UNITED STATES DEPARTMENT OF THE INTERIOR BUREAU OF LAND MANAGEMENT

PLUG AND ABANDONMENT PROCEDURE

Jicarilla 147 #3E

CONDITIONS OF APPROVAL

Jicarilla 147 #3E Proposed P&A

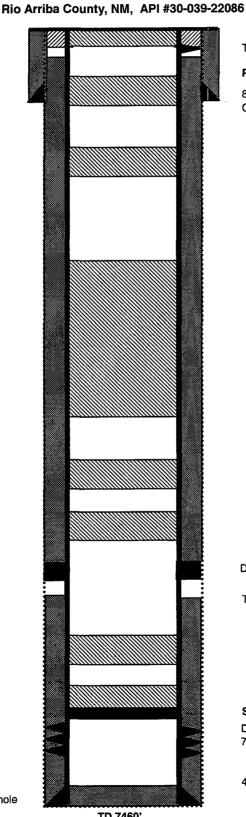
- 1. Plugging operations authorized are subject to the attached "General Requirements for Permanent Abandonment of Wells on Federal and Indian Lease."
- 2. Farmington Office is to be notified at least 24 hours before the plugging operations commence (505) 599-8907.
- 3. The following modifications to your plugging program are to be made:
- a) Place the Gallup plug from 6124' 6024'.
- b) Place the Chacra plug from 3734' 3634'.
- c) Place the Pictured Cliffs/Fruitland/Kirtland/Ojo Alamo plug from 2869' 2126'.
- d) Place the Nacimiento plug to 855' 755'.

You are also required to place cement excesses per 4.2 and 4.4 of the attached General Requirements.
